TOWN OF CORTLANDT PLANNING BOARD

MEETING AGENDA.....PLANNING BOARD
TOWN OF CORTLANDT
6:30 THURSDAY EVENING*
JUNE 5, 2025

- PB 2024-6** **a.** Application of Richard Williams, P.E., on behalf of JAM Storage, LLC, for the property of Francisco Portillo, for Site Plan Approval and a Wetland Permit for the construction of an approximately 60,000 sq. ft. self-storage facility and related site improvements for property located at 2059 Albany Post Rd. Drawings dated May 27, 2025.

DRAWING NO. **EX-1** SHEET 2

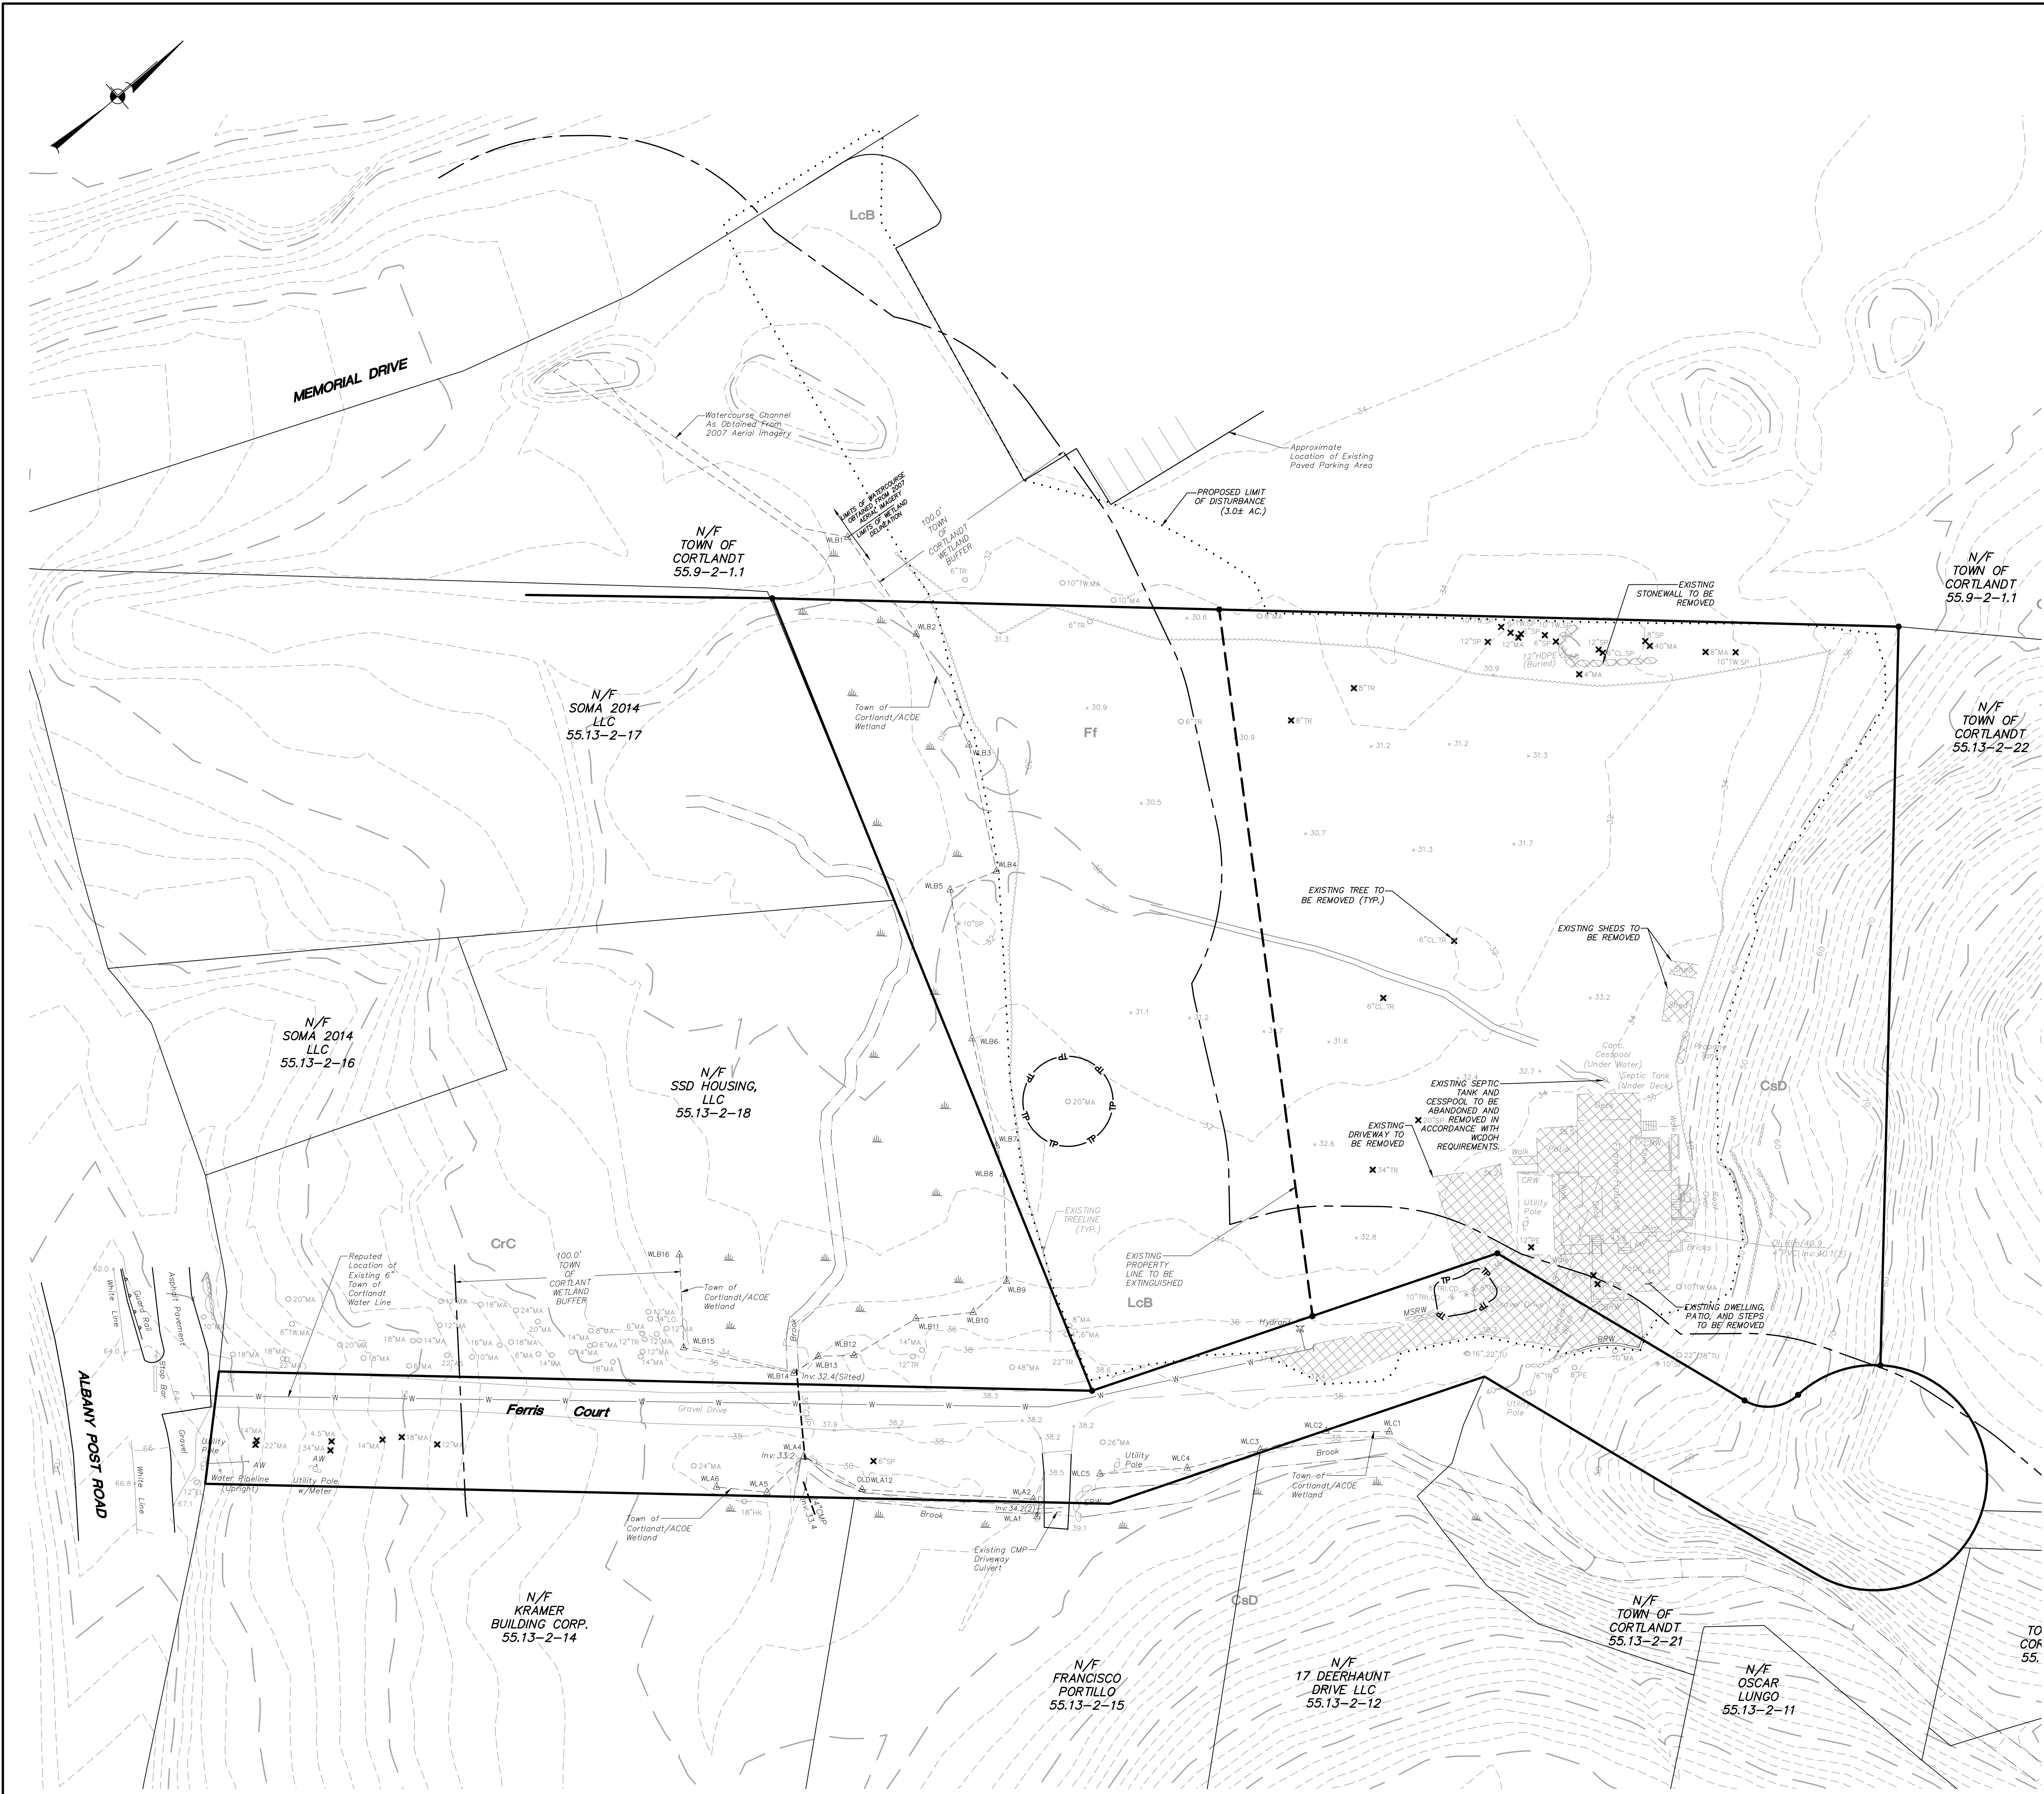
- b. *Sheet EX-1 shows trees to be removed. The applicant is advised that as per Chapter 283 (Trees) of the Town Code all trees located within 50' of any proposed disturbance must be field located and inventoried and a report as to the tree size, species and health must be submitted by a Town-approved arborist. The Planning Board will make a determination on the granting of the tree removal permit as per Section 283-7 of the Town Code.*

4. *Sheet EX-1 - Rectify removal of septic tank and cesspool notes to reflect in accordance with WCDOH, not PCDOH.*

5. *Sheet EX-1 - Include all trees to be removed on this plan. For example, a 26-inch tree is not shown to be removed, but is located within the proposed driveway.*

6. *Sheet EX-1: Provide limits of disturbance on this Sheet.*

7. *Sheet EX-1 - Existing water line is referenced as a private water main. It is a Town of Cortlandt water line and should be denoted as such. Rectify on other plan sheets.*

The intent of this resubmission is to review the alternate access plan with the Planning Board and address the technical comments. The owner is currently engaging an arborist to have the requested inventory and subsequent survey performed. This information will be added to our next submission and will also include the required Tree Removal Permit.

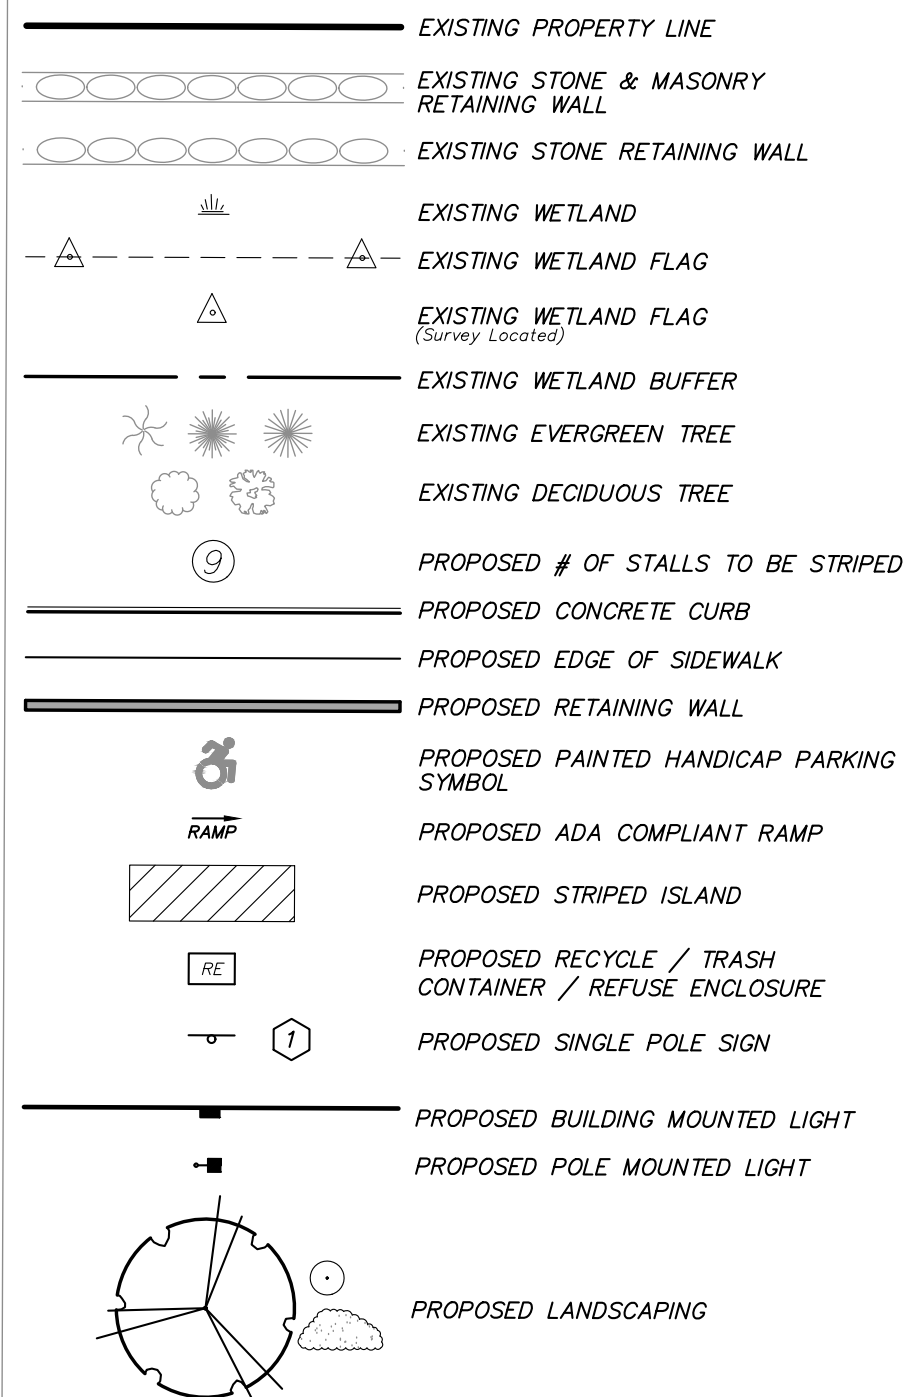
8. *Sheet SP-1 - Provide Landscaping in accordance with Town Standards.*

9. *Sheet SP-1 -Provide soil restoration requirements on this Sheet as outlined in the SWPPP. Identify all areas of soil restoration.*

10. *Sheet SP-1 - Provide signage Location for the ADA parking space and access aisle.*

11. *Sheet SP-1 -Provide a stop bar and stop sign at the end of the proposed driveway to prevent conflicts with the shared access to Albany Post Road.*

12. *Sheet SP-1 - Provide a fence or guardrail, minimum 42-inches high along the top of the retaining wall.*

13. *Sheet SP-1 - Provide radii for the new access along Ferris Court and proposed access drive around the Building.*

14. *Sheet SP-1 - Provide signage at the face of the Building indicating no parking within the striped area*

15. *Sheet SP-1 - Show the building ingress and egress Locations.*

16. *Sheet SP-1 - Provide a curb along the eastern edge of the proposed driveway along Ferris Court to direct runoff into catch basins. .*

17. *Sheet SP-1 - Consider substituting Landscaping or grass adjacent to the storage facility in Lieu of striping in some areas to break up the monotony of asphalt.*

18. *Sheet SP-1 - Provide for snow storage on-site and along Ferris Road. The reconstruction of Ferris Road stretches over 300-feet and snow storage will be necessary.*

19. *Sheet - SP-1 - Provide for guiderails either along Ferris Court due to the elevation change between the top of retaining wall and adjoining grades.*

A landscape plan has been prepared and is illustrated on Drawings SP-1.

A 25' wide vegetative pond buffer has been provided around the proposed gravel wetland and shown on the project drawings on Drawing SP-1.
